FROM: Rebecca Ballo  
Historic Preservation Section Maryland-National Capital Park & Planning Commission  
Historic Area Work Permit #1054192 - Revisions to retaining wall treatments associated

SUBJECT: with shared use path.

**Case Number:** 1054192

**PROPOSAL:** Revisions to retaining wall treatments associated with the previously approved shared-use path.

SCALE: AS SHOWN DATE: DECEMBER 2021 **ST-101**

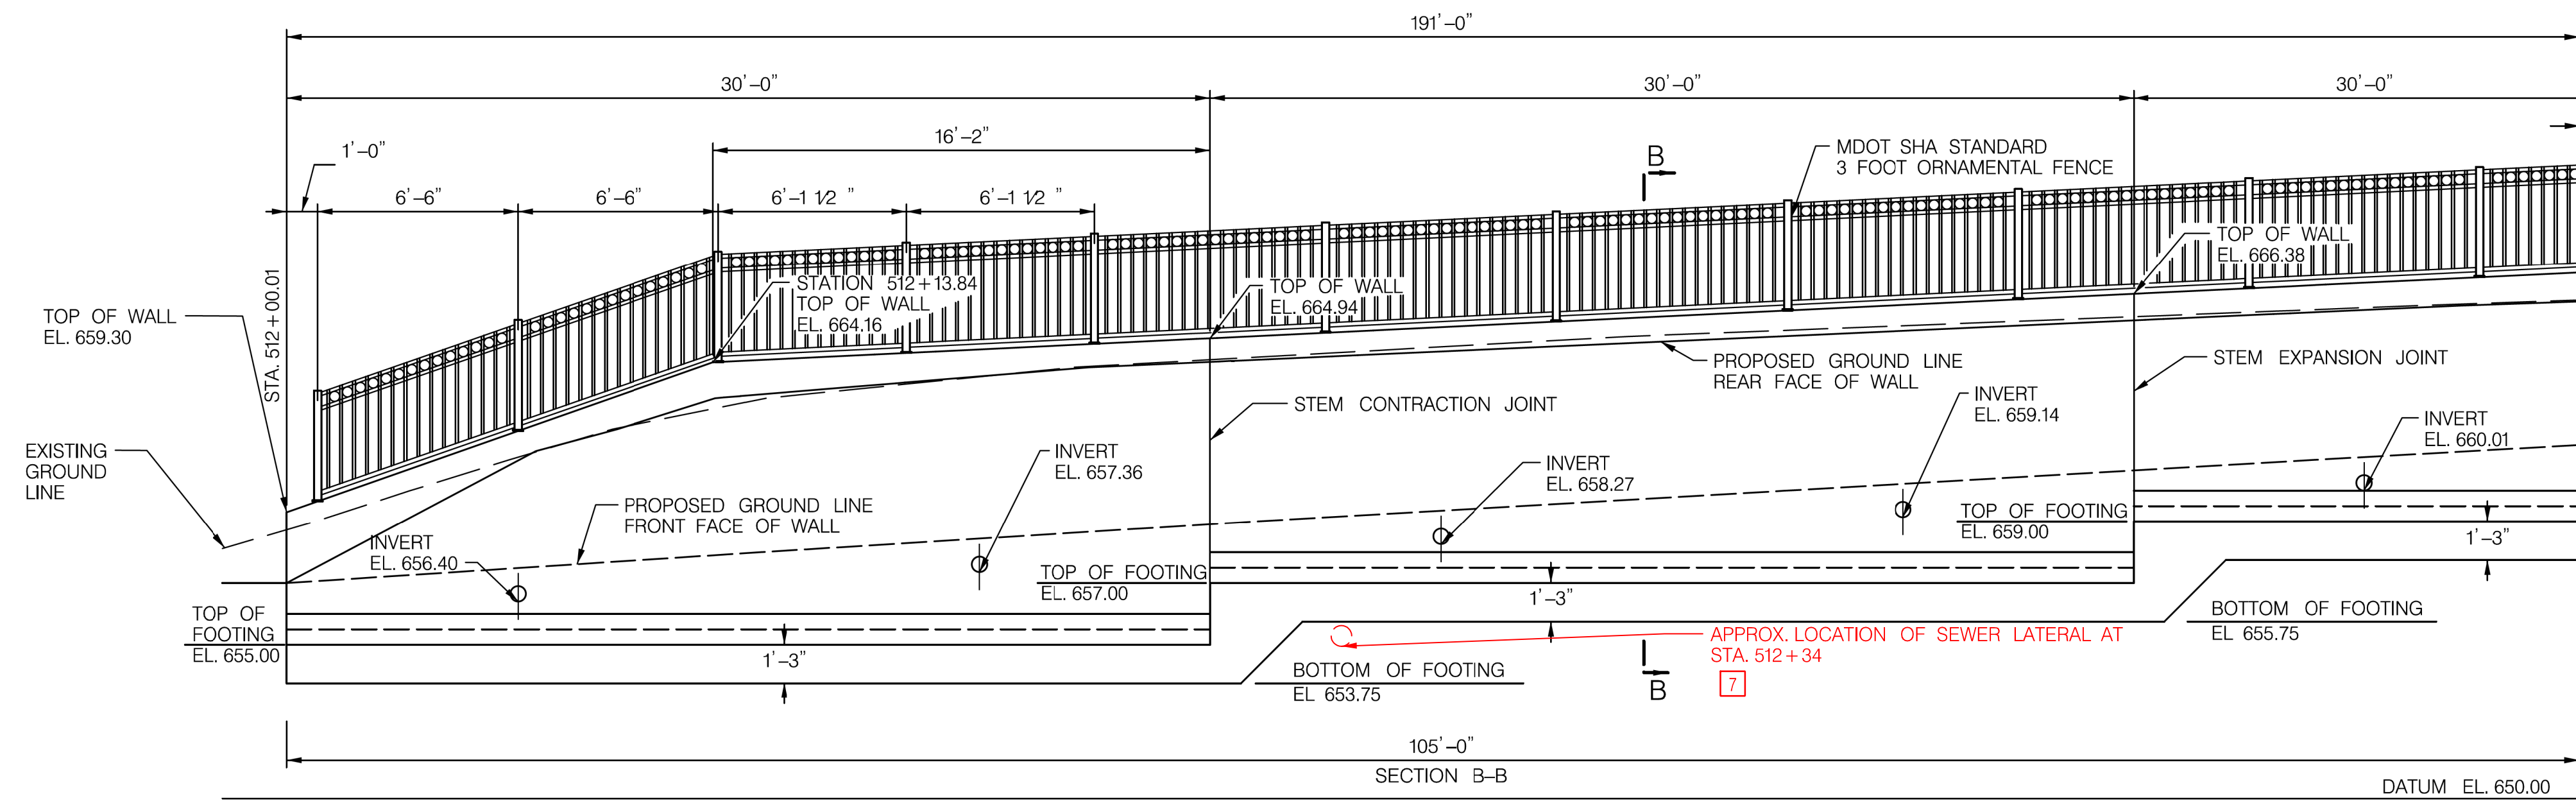
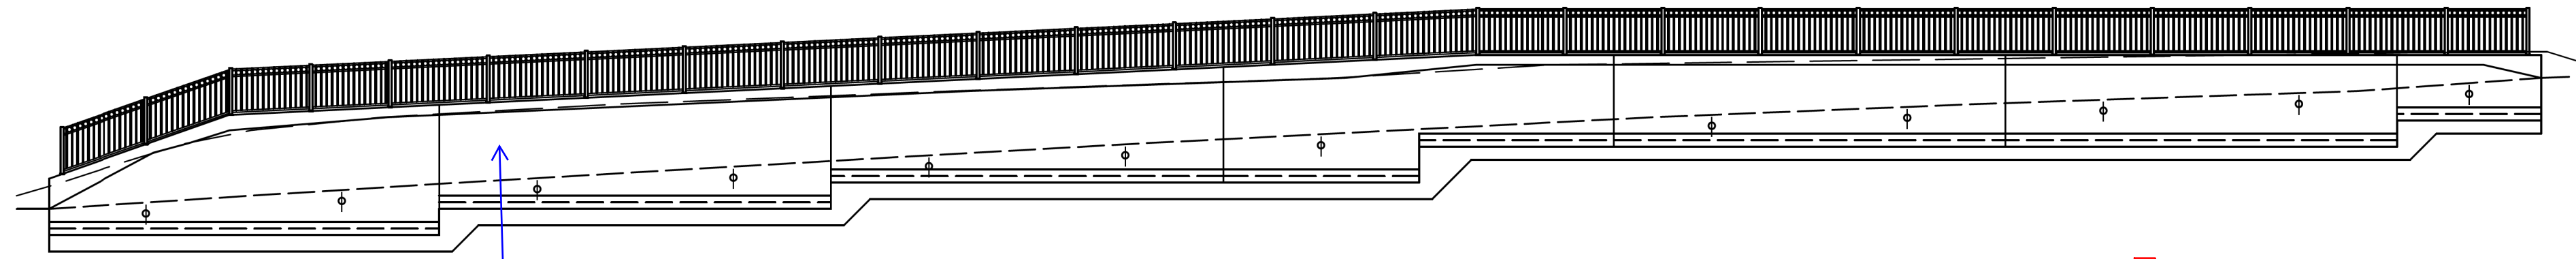
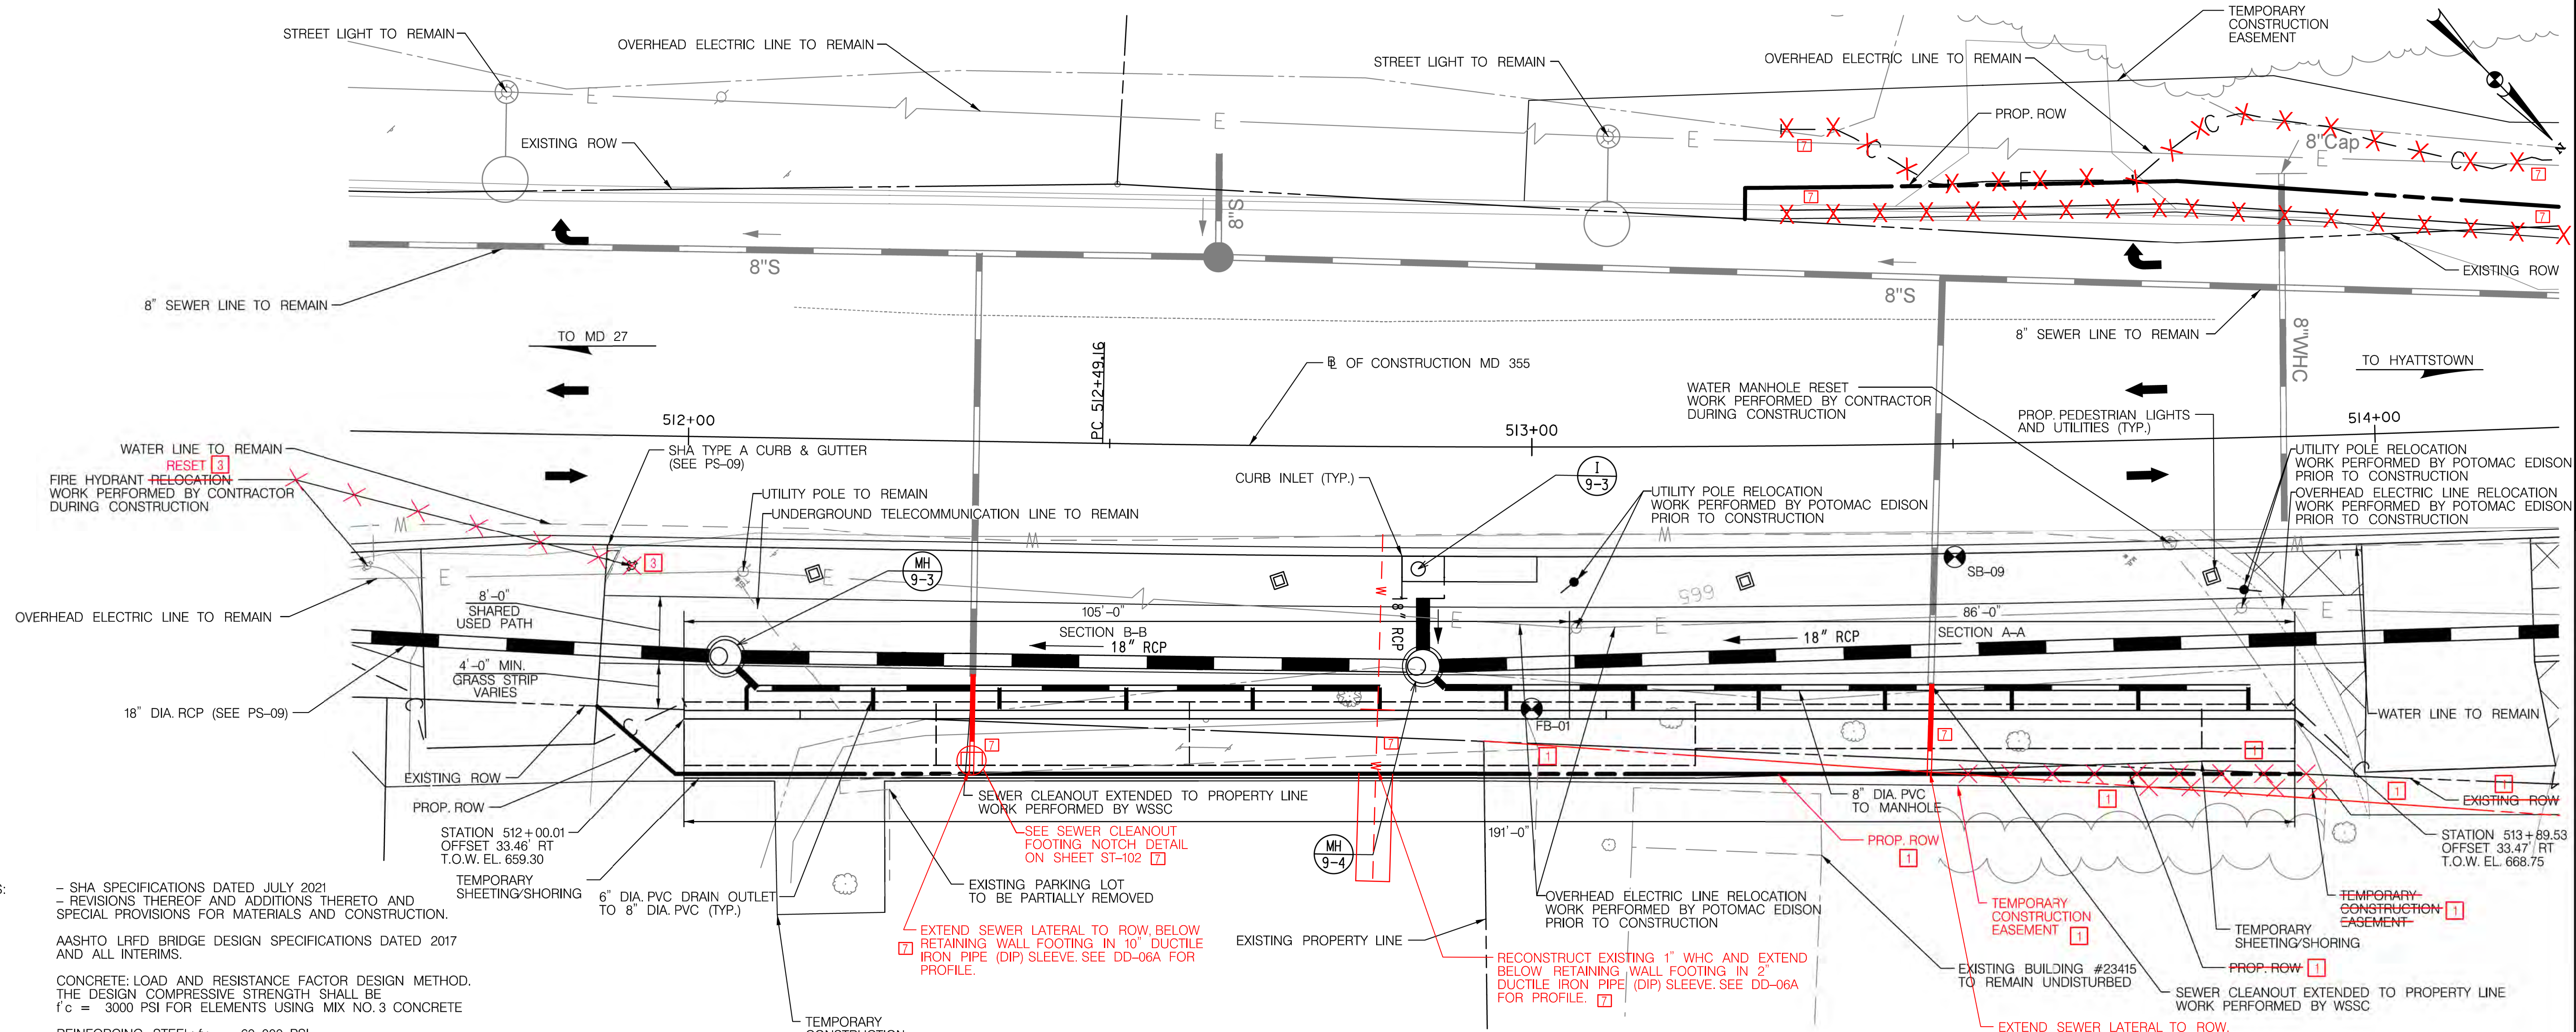
The Stone Facing is approved, NOT the white textured block face.
